# Access Compliance Report

## Public Rights-of-Way

Intersection ID: N/A	Main Street: CAROLINA_PAVILION_DR	Cross Street: N/A	Location: NW
ADA ID: D1AF3BF1B571	Ramp Type: Perp	Initial Pass/Fail: Fail	Overall Compliance: No
		Severity Score: 12.5

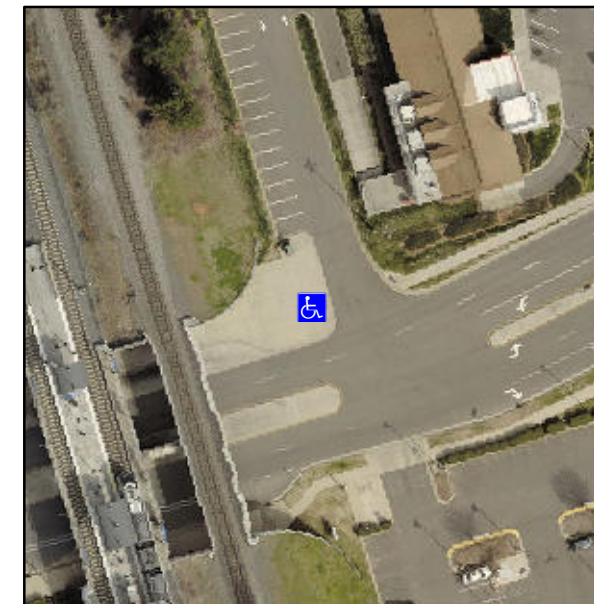
**Not Found, R304.5.3**

Compliance	Description	Data	Compliance	Description	Data
N/A	Ramp Length (in)	83.0	Yes	Ramp Slope (%)	8.2
Yes	Ramp Width (in)	48.0	No	Ramp XSlope (%)	6.0
N/A	Flare Type LT	N/A	N/A	Flare Type RT	N/A
N/A	Flare Slope LT (%)	N/A	N/A	Flare Slope RT (%)	N/A
N/A	Flare Traversable LT?	N/A	N/A	Flare Traversable RT?	N/A
N/A	Landing Length (in)	N/A	N/A	DWS Provided?	N/A
N/A	Landing Width (in)	N/A	N/A	DWS Contrast?	N/A
N/A	Landing Slope (%)	N/A	N/A	DWS Length (in)	N/A
N/A	Landing X Slope (%)	N/A	N/A	DWS Full Width?	N/A
N/A	Landing Curb? (Y/N)	N/A	N/A	DWS Offset (in)	N/A
N/A	Shared Landing?	N/A			
N/A	Gutter Ponding?	N/A	N/A	Gutter Slope (%)	N/A
N/A	Gutter Lip Ht (in)	N/A	N/A	Gutter X Slope (%)	N/A
N/A	Painted X Walk1?	No	N/A	Painted X Walk2?	N/A
	X Walk 1 Direction	To E		X Walk 2 Direction	N/A
N/A	X Walk 1 Width (in)	N/A	N/A	X Walk 2 Width (in)	N/A
	X Walk 1 Slope (%)	0.3		X Walk 2 Slope (%)	N/A
	X Walk 1 X Slope (%)	1.9		X Walk 2 X Slope (%)	N/A

**Remove & Replace Entire Ramp.**
